Re: PLUS Response (Revised)
Saratoga
DBF #1231A036

This letter is in response to comment received from your office dated, June 11, 2007. We offer the following item-by-item response narrative for your review.

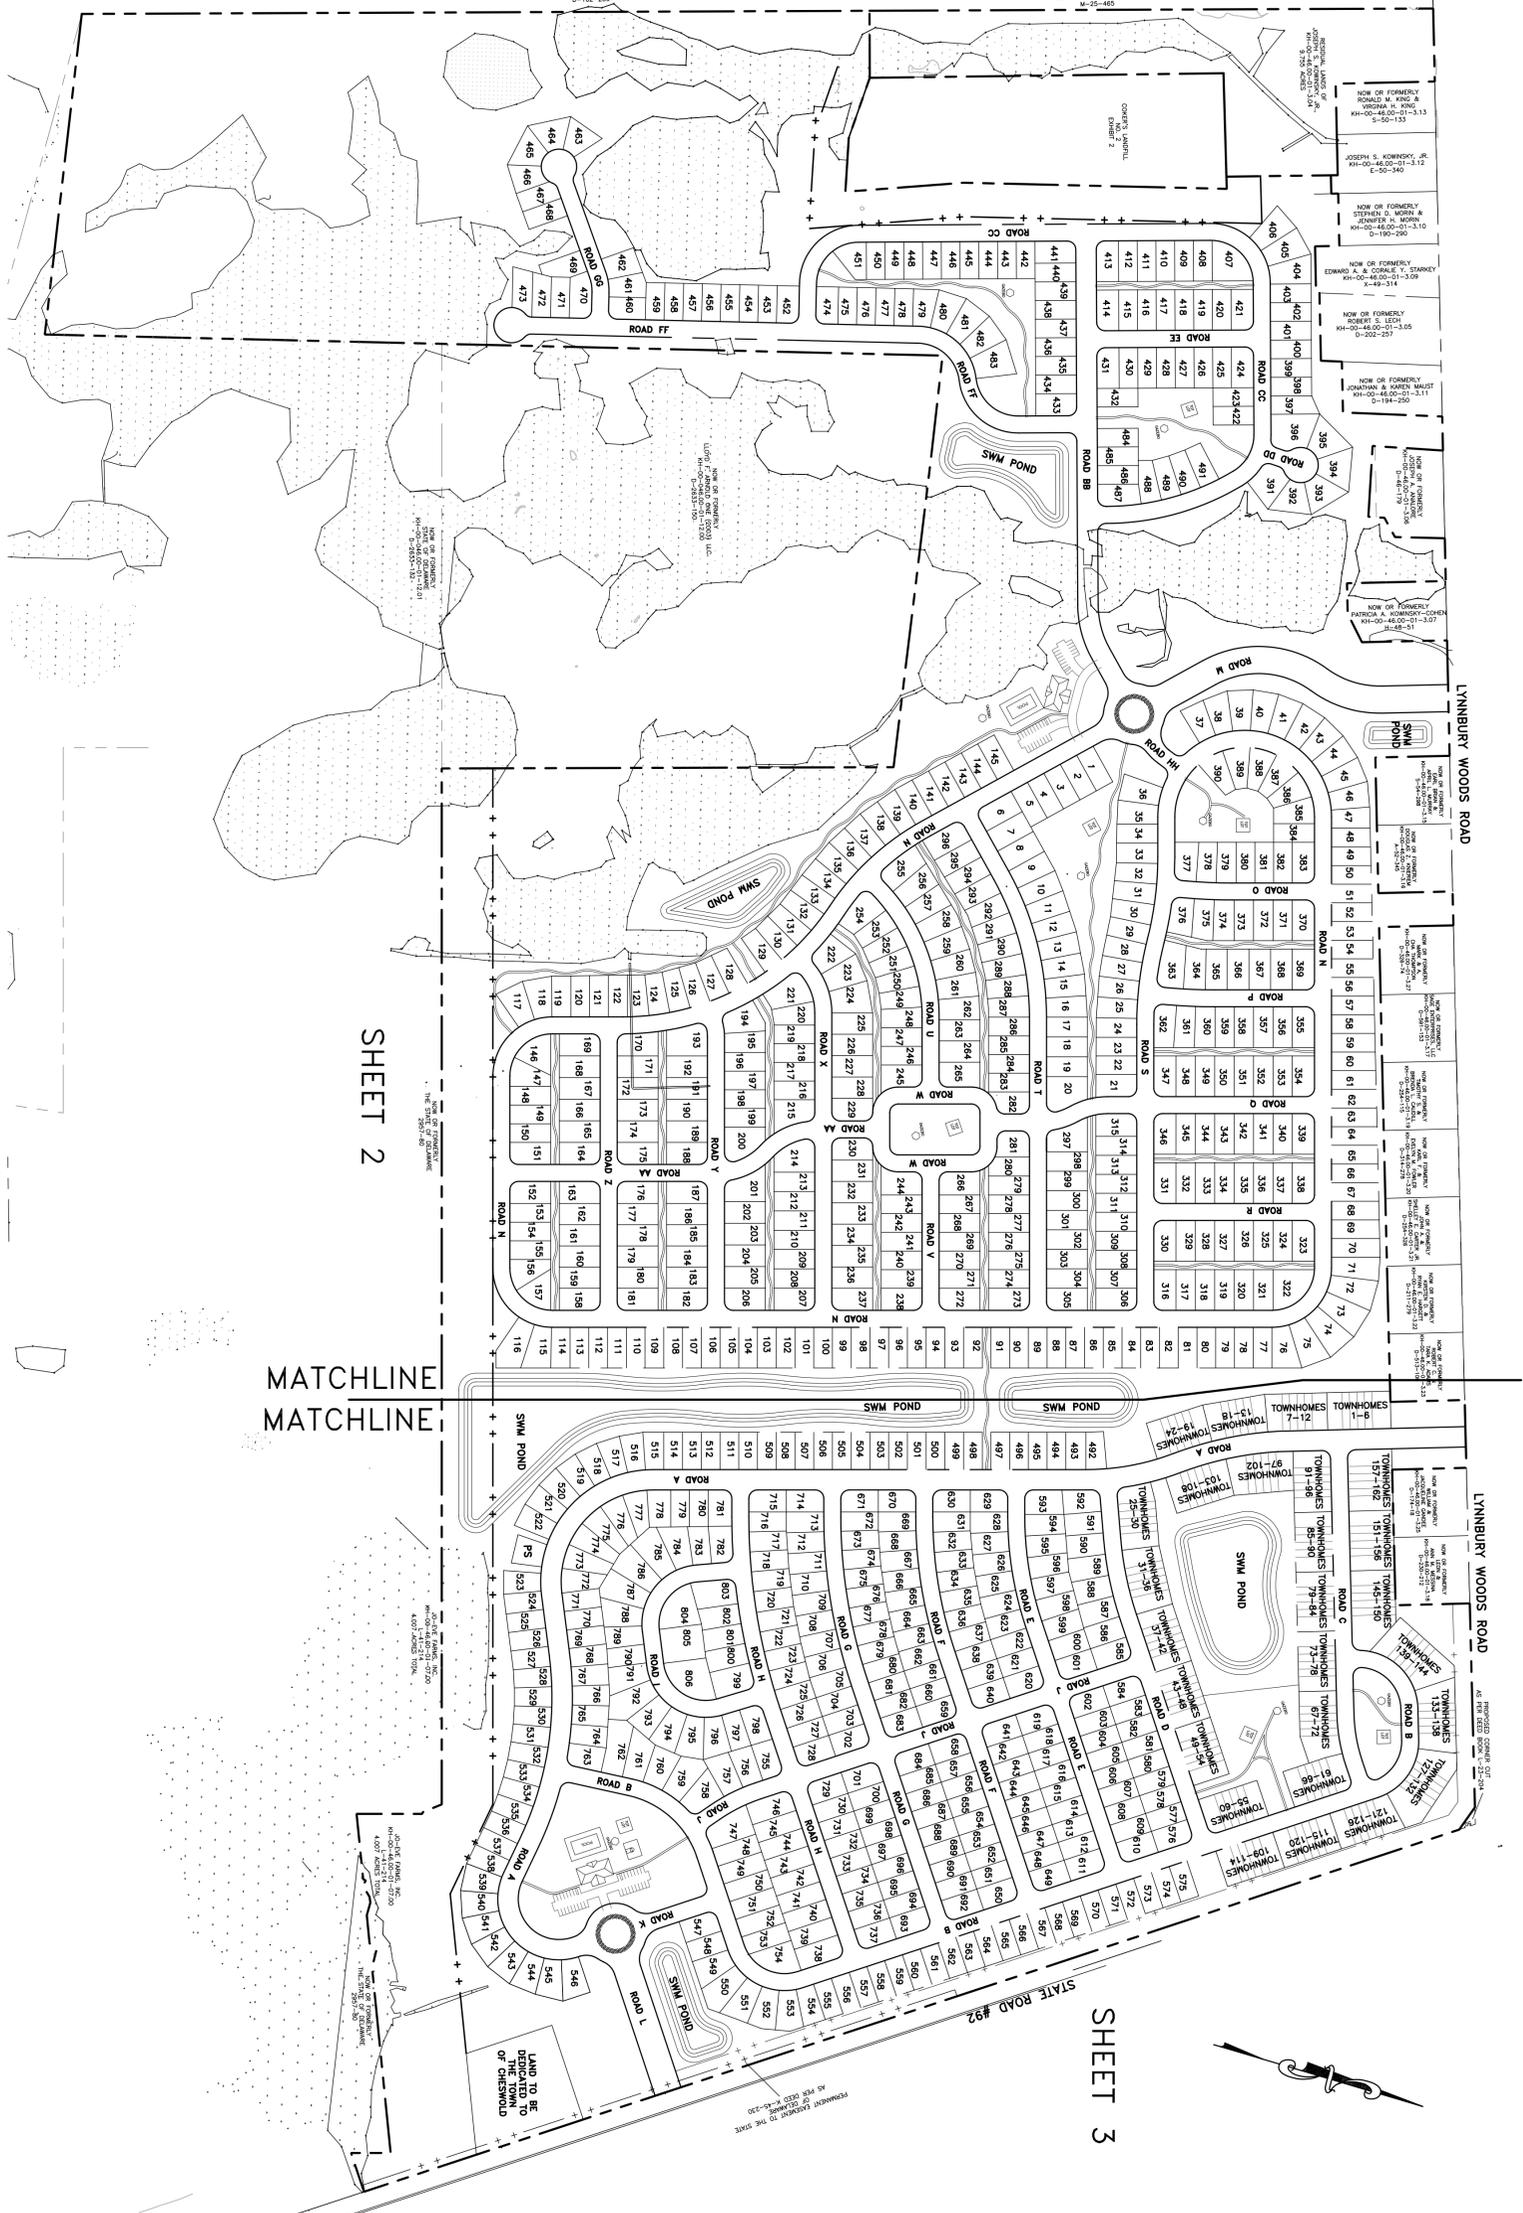
- *Some areas of the site plan contain inadequate wetland buffers. At least 3 stormwater management ponds, a community pool area, approximately lots 117-140, 392-394, 463-468, Roads BB, CC, GG, FF and M appear to be within 100 feet of wetlands and should be pulled out of this important buffer zone. There should be at least a 100-foot buffer between lots/infrastructure and wetlands.*

According to our GIS database, there is an isolated wetland known as a Coastal Plain Pond or Delmarva Bay adjacent to lot #'s 463-464. This unique wetland provides breeding habitat for a variety of animals, including amphibians and invertebrates, and often supports a unique and rare assemblage of plants. Upland forest buffers around these ponds are also critical, protecting the wetland from excess nutrients and invasion by non-native species. This buffer also provides critical habitat for salamanders during most of their annual life cycle.

- 2. To protect the existing coastal plain pond, Lot #s 463-468 should be removed as well as the associated cul-de-sac so that an adequate wetland buffer of at least 300 feet is left intact around the perimeter of the pond. This buffer width is recommended because of the sensitive nature of the wetland, potential for rare species, as well as providing adequate upland breeding areas (for species such as salamanders).*

The developer acknowledges DNREC's concerns regarding 100-foot buffers and drainage concerns. The site meets the wetland buffer requirements per the Town of Cheswold's Code. We also removed the pond from the wetlands at the entrance and the other two ponds of concern are at least 25 feet from the wetlands.

Lots 463-464 were adjusted so that a buffer of approximately 75 feet between the wetlands and lots is provided.

The developer is preserving 69 of the existing 80 acres of forested area, which is approximately a 15% loss.

Lots 463-464 were adjusted so that a buffer of approximately 75 feet between the wetlands and lots is provided.
